# TABLE OF CONTENTS
# ROCKY FLATS PLANT FINAL PHASE I RFI/RI WORK PLAN
# WOMAN CREEK PRIORITY DRAINAGE OPERABLE UNIT 5

# DOCUMENT MODIFICATION REQUEST (DMR)

| 1. Date | 25. |
|---|---|
| December 8, 1994 | DMR. No. 94-DMR-ERM-0144 |

| 4. Originator's Name/Phone/Page/Location<br>Mark R. Wood/8784/5904/080-641 | 5. Document Title: FINAL PHASE I RFI/RI WORK PLAN FOR OPERABLE UNIT 5 WOMAN CREEK PRIORITY DRAINAGE, Volume III - Text to Technical Memorandum No. 15 - Amended Field Sampling Plan |

FIGURE 3.1.2.2-1

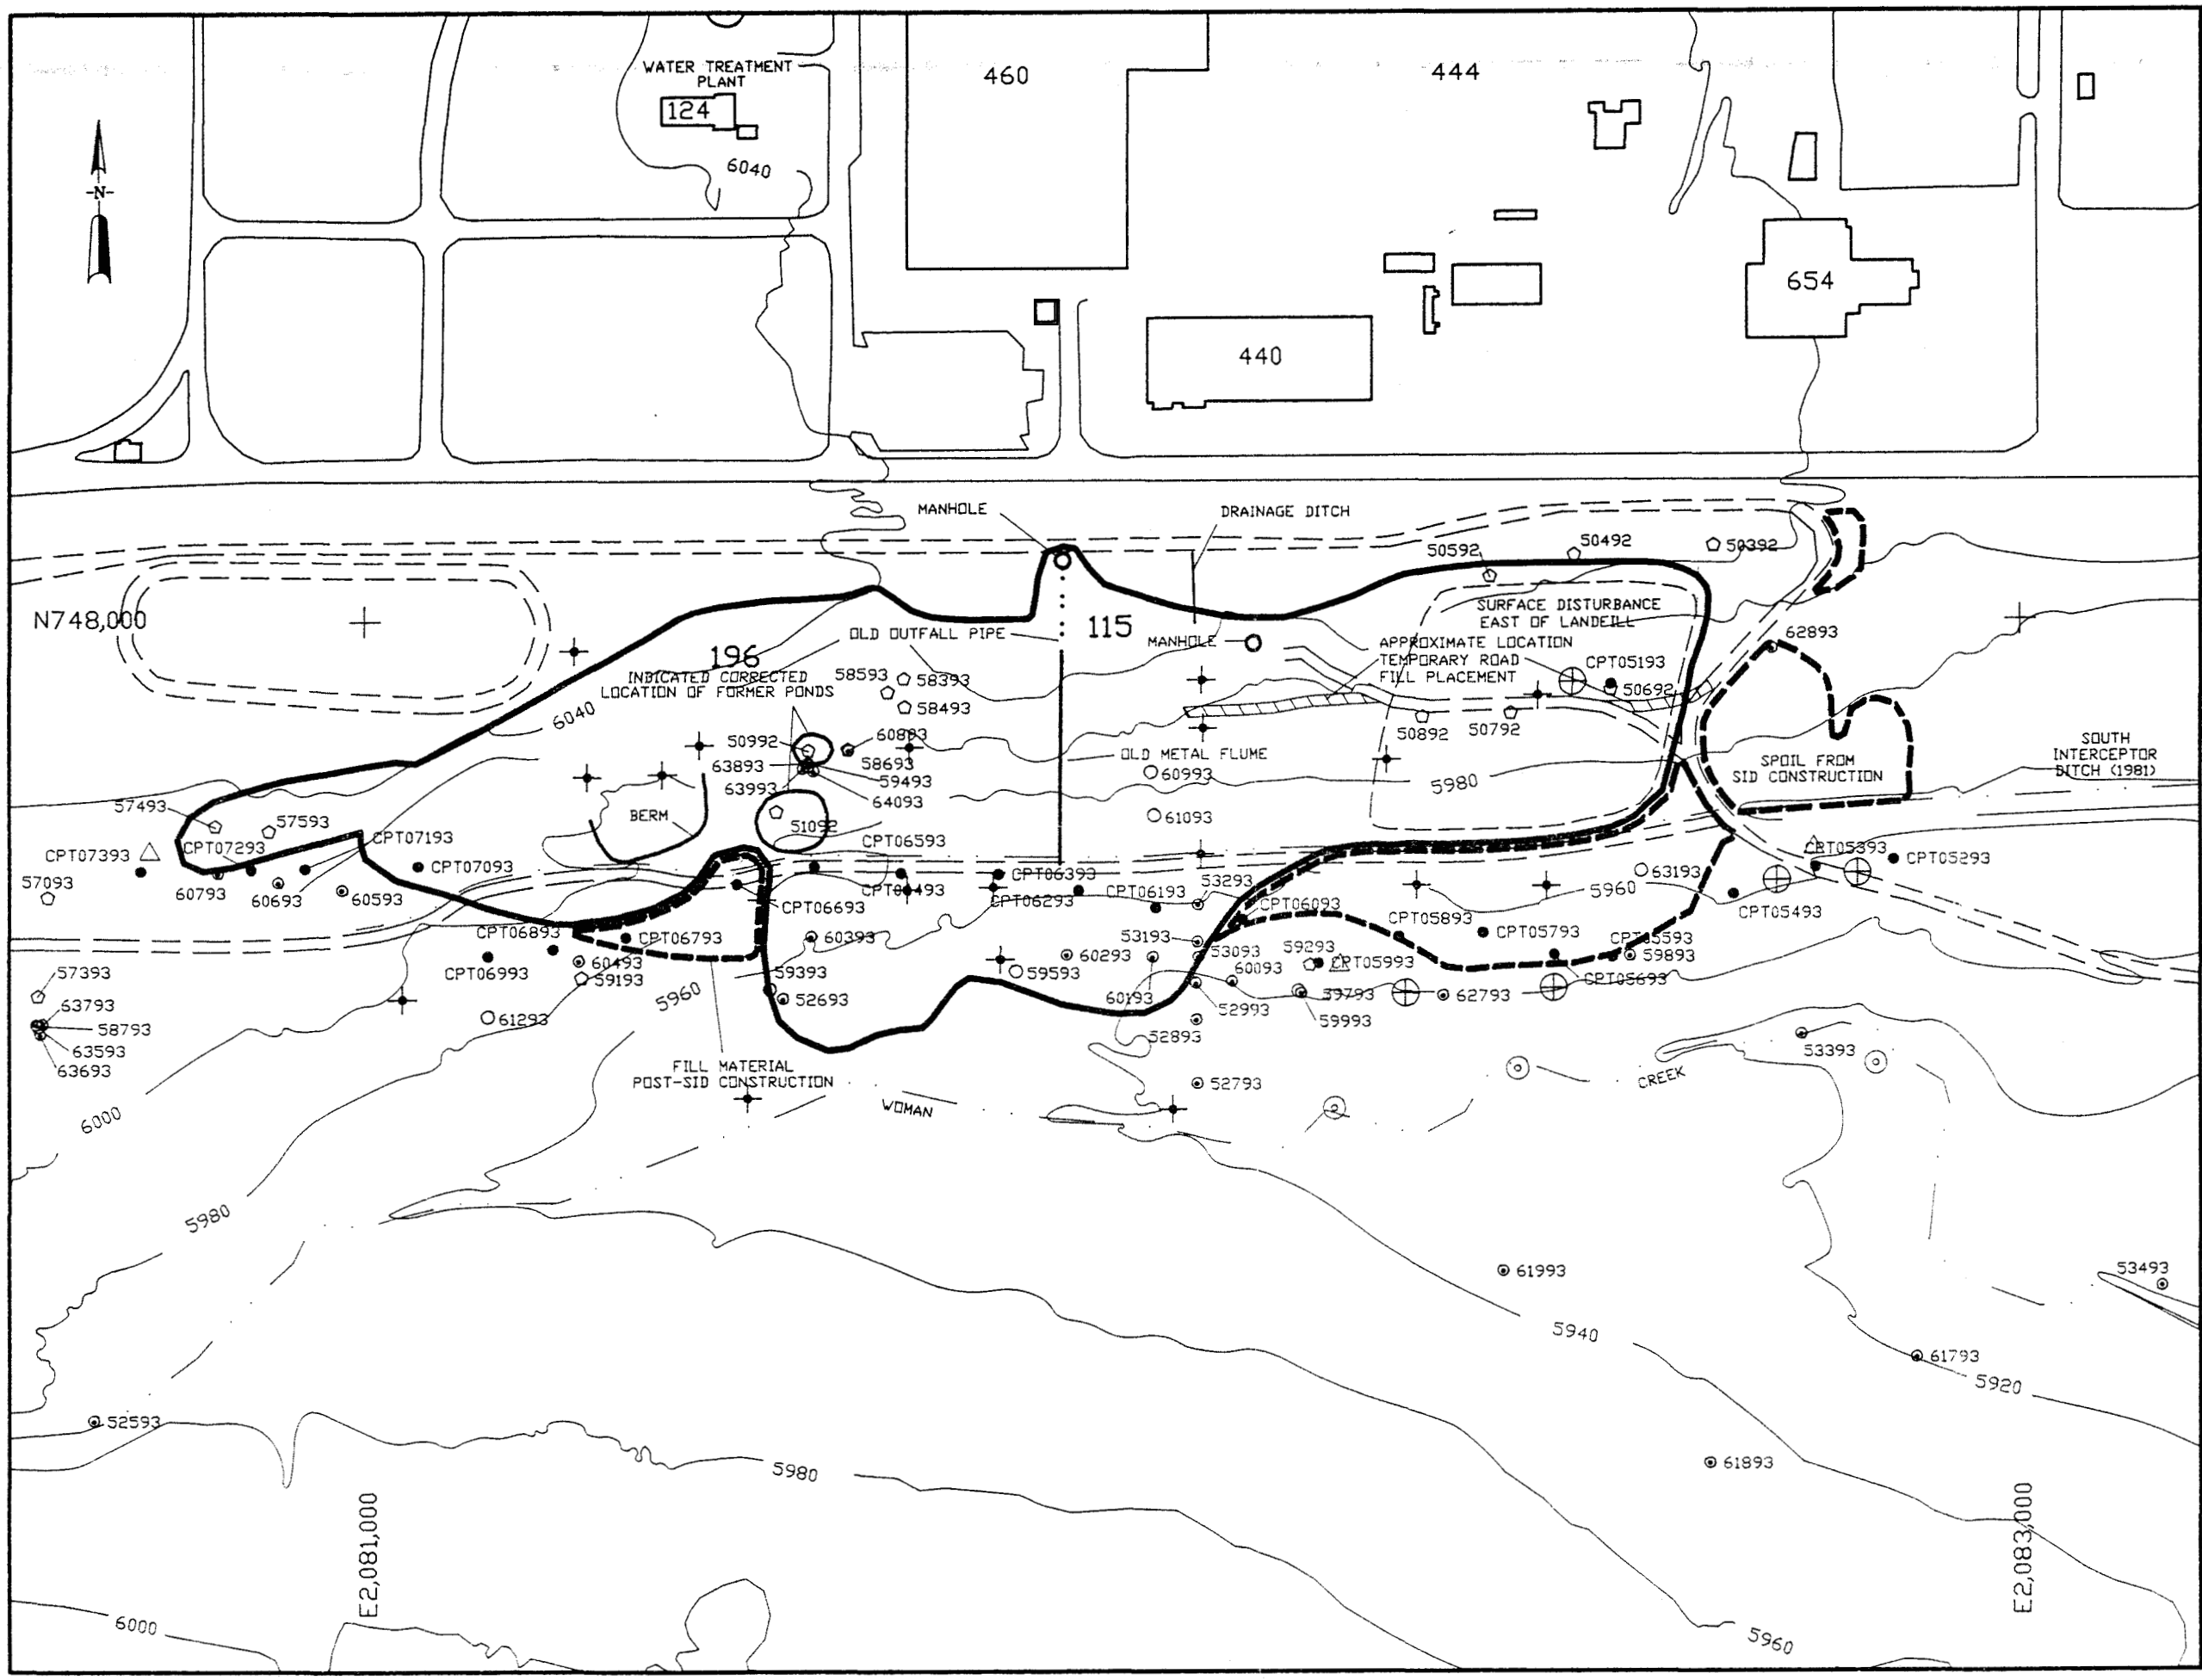
| 8. Item | 9. Page | 10. Step | 11. Proposed Modifications |
|---|---|---|---|
| 1 | 3-7 | 3.1.2.2 | Insert the following paragraph before first paragraph.<br>To facilitate the access of the hollow-stem auger drill rig to the geotechnical borings located in the central landslide area, the subcontractor will coordinate with Construction Management, Heavy Equipment and Labor, Trucking, and Ecology and Watershed Management for the purpose of constructing a temporary fill road. The temporary fill road will be located as shown in Figure 3.1.2.2-1. MRW 12/12/94 The temporary fill road will be placed without excavating or disturbing the existing hillside to allow level access for the drill rig to the boring location. Heavy Equipment and Labor and Trucking will provide the necessary heavy equipment consisting of but not limited to a front-end loader, dump truck, and bull dozer. Clean fill material will be provided by Heavy Equipment and Labor and compacted in place with the bull dozer or front end loader. Ecology and Watershed Management will clear the access route and provide direction regarding reseeding and revegetating the fill material at completion of the task. Access to the temporary fill road will be blocked by trenching at the east end of each fill material placement area upon completion of the task. |
| 2 | | | Insert Revised Figure 3.1.2.2-1<br>MRW 12/12/94 |

[redacted]ss construction of a temporary fill road to access geotechnical boring locations in the central portion of IHSS 115 in OU5, Technical Memorandum No. 15. The DOE-RFFO [redacted]erpart, Kurt Muenchow, verbally concurs with the scope of this Document Modification Request.

To facilitate the access of the hollow-stem auger drill rig to the geotechnical borings located in the central landslide area, the subcontractor will coordinate with EG&G Construction Management, Heavy Equipment and Labor, Trucking, and Ecology and Watershed Management for the purpose of constructing a temporary fill road. The temporary fill road will be located as shown on Figure 3.1.2.2-1. The temporary fill road will be placed without excavating or disturbing the existing hillside to allow level access for the drill rig to the boring location. Heavy Equipment and Labor and Trucking will provide the necessary heavy equipment consisting of, but not limited to, a front-end loader, dump truck, and bulldozer. Clean fill material will be provided by Heavy Equipment and Labor and compacted in place with the bulldozer or front-end loader. Ecology and Watershed Management will clear the access route and provide direction regarding reseeding and revegetating the fill material at completion of the task. Access to the temporary fill road will be blocked by trenching at the east end of each fill material placement area upon completion of the task.

As part of the groundwater investigation, nine geotechnical borehole locations (Figure 3.1.2.2-1) will have two-inch nominal diameter PVC piezometers installed. If sufficient groundwater is present, the piezometers will be sampled on a quarterly basis for one year for OU5 target analytes (Table 3.1.2-1). These piezometers will provide water level data for the hydrogeologic model. The piezometers will be installed in accordance with SOP GT.6, Monitoring Wells and
